Consensus Recommendations  
to Improve Protocols 2 and 3 for Defining Stream Restoration Pollutant  
Removal Credits

October 27, 2020

Prepared by:  
David Wood and Tom Schueler, Chesapeake Stormwater Network

## Appendix I. Response to Comments

**Figure 2.** Floodplain Restoration by Raising the Stream Bed (Courtesy: Joe Berg, Biohabitats)

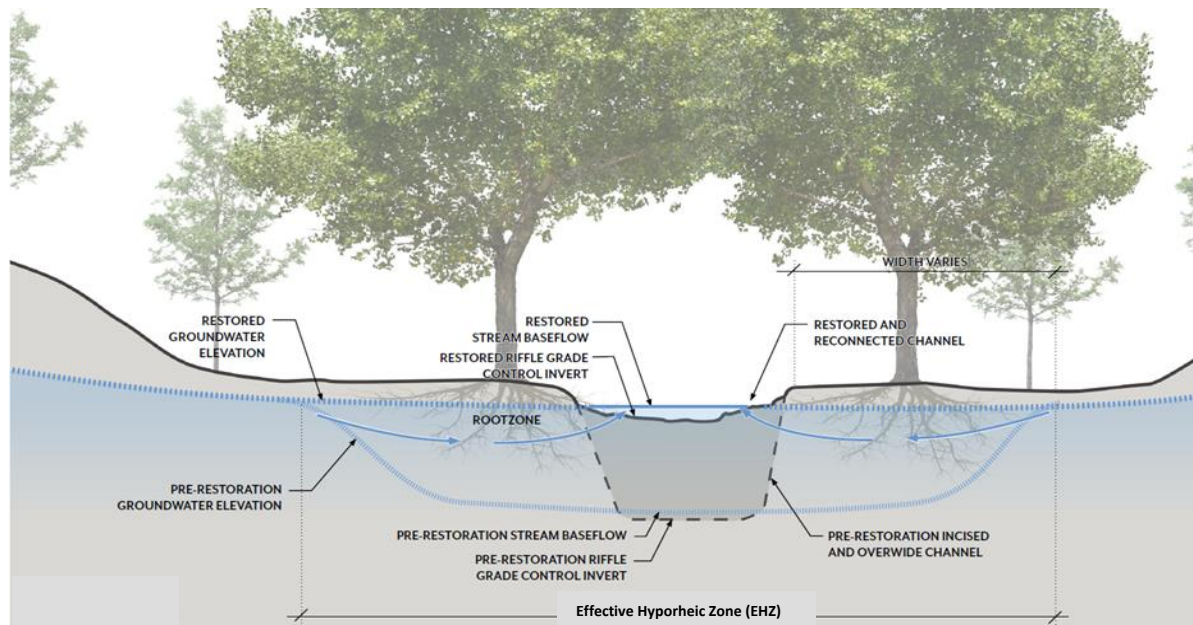
In addition, Figures 2 and 3 do not clearly illustrate these differences. Labels that reflect the narrative descriptions, including the 18 inch criteria, would provide greater understanding.

4. **Figure 2** is a poor sketch because it's not clear or well labeled.

**Figure 3.** Depiction of EHZ boundaries cross-section and plan view

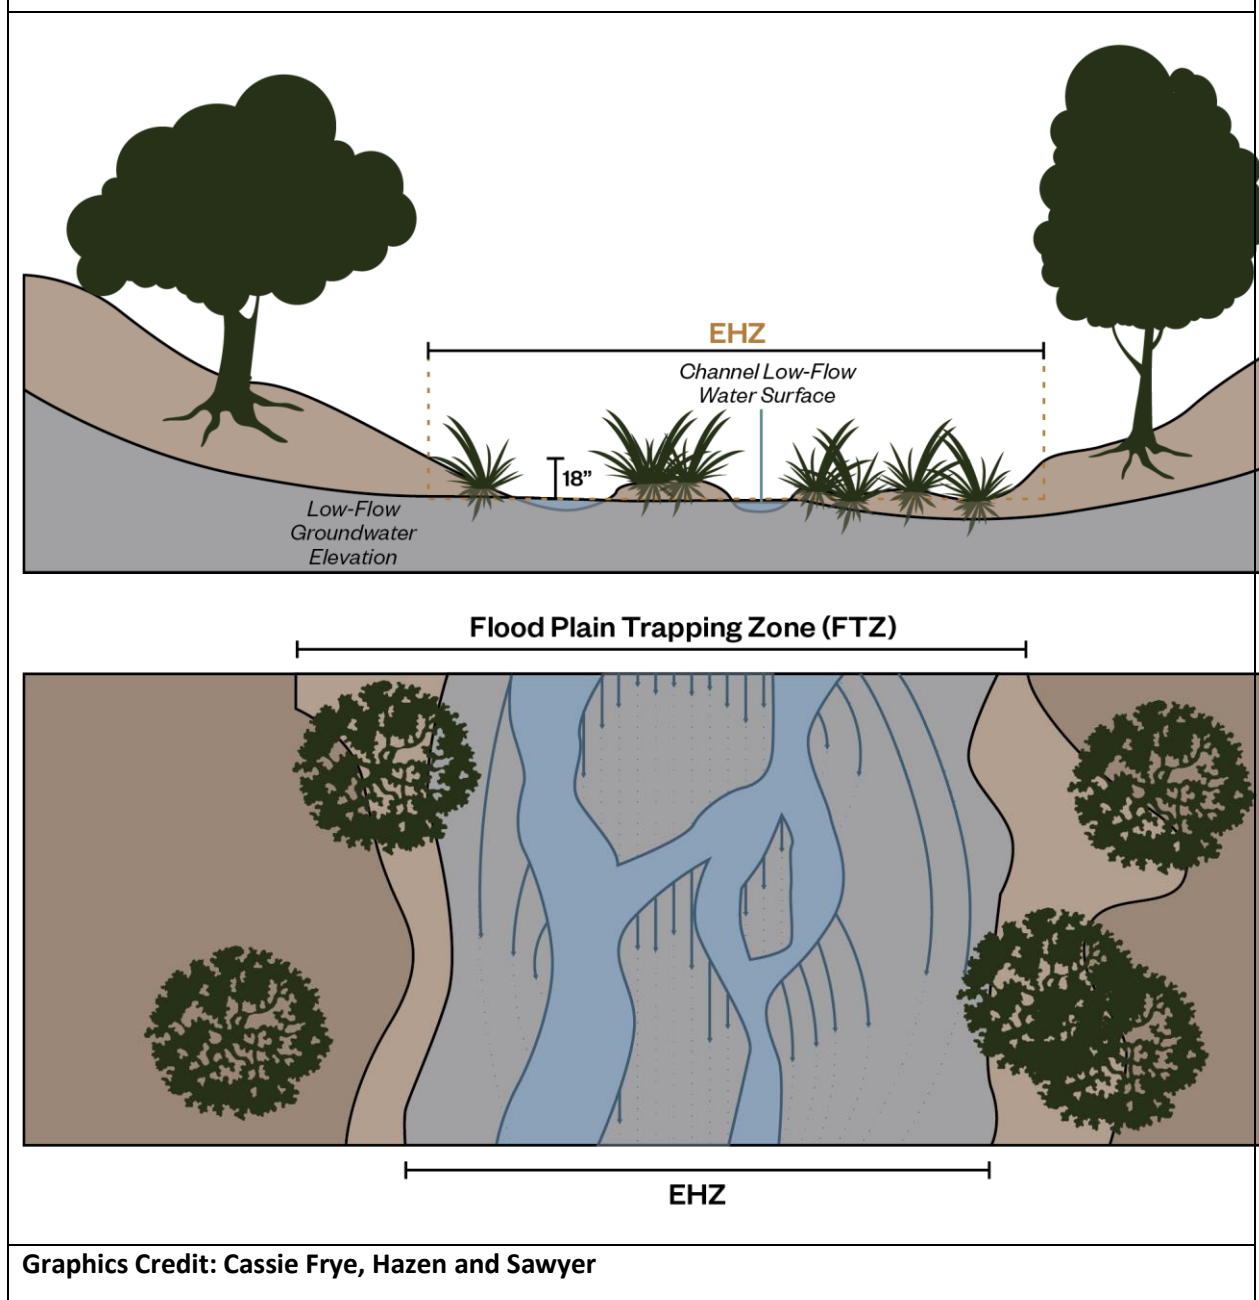
17. In Figure 3, please consider using a detail that does not have the name of a specific practitioner. This affords the specific practitioner a competitive advantage as the Department will be referring our stakeholders to this document.

2. The definition of the HEZ and EHZ needs further clarification both in the narrative and Figure 3 and how it applies to RSB projects. Please see Figure 3 for further details.

**Figure 4.** Illustration of site-specific discount factors for Protocol 2 (Courtesy: Jeff Hartranft, PA DEP; and Art Parola, University of Louisville).

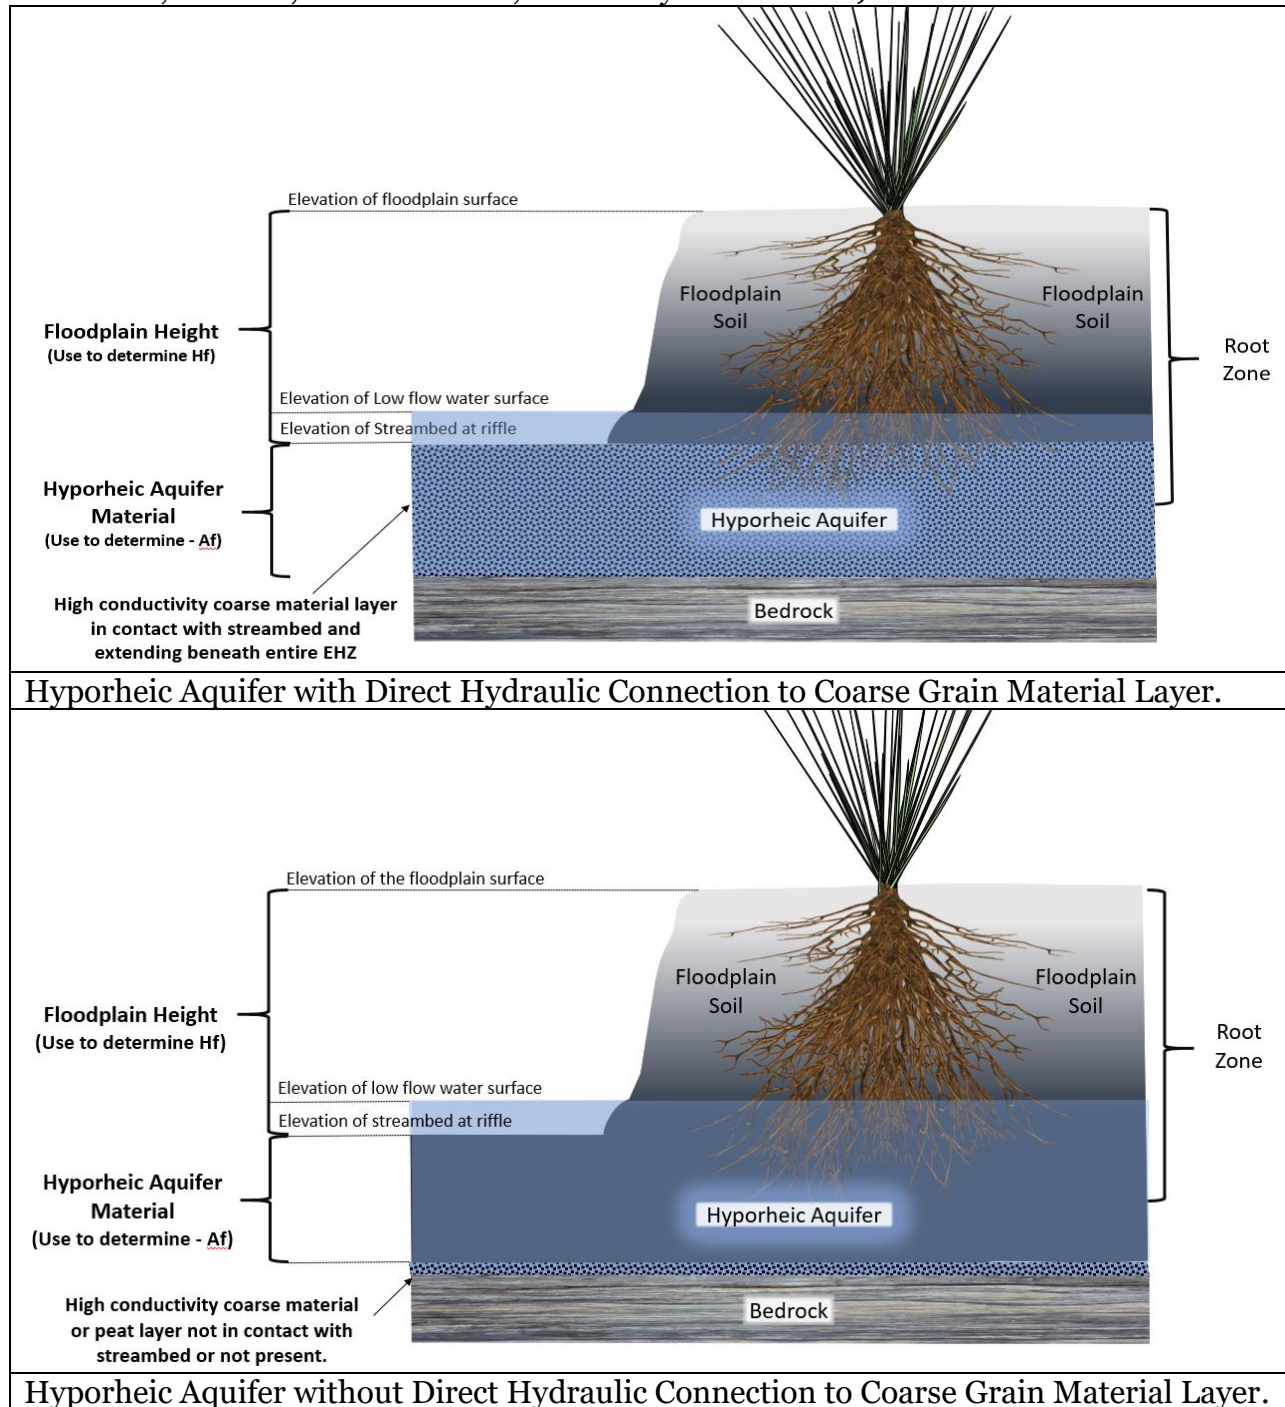
8. Pages 21 and 22: Figures 2, 3 and 4 seem very important yet are not easy to read. Figure 2 is a hybrid of LSR and RSB and contains EHZ and FTZ, but only for LSR, RSB uses old terminology of HB for some reason. Figures 3 has HEZ and EHZ but Figure 4 only specifically labels HEZ. The Text says that EHZ and FTZ are expressed

in Figures 2 and 4 but there's no FTZ in figure 4. Would it be useful to have same type of figure style for both plan view and section view and accurately refer to terms contained in figures in text? In addition, FTZ is only discussed in Protocol 3 - best to have a few robust, complete diagrams to which the two "Protocol" sections refer if possible.
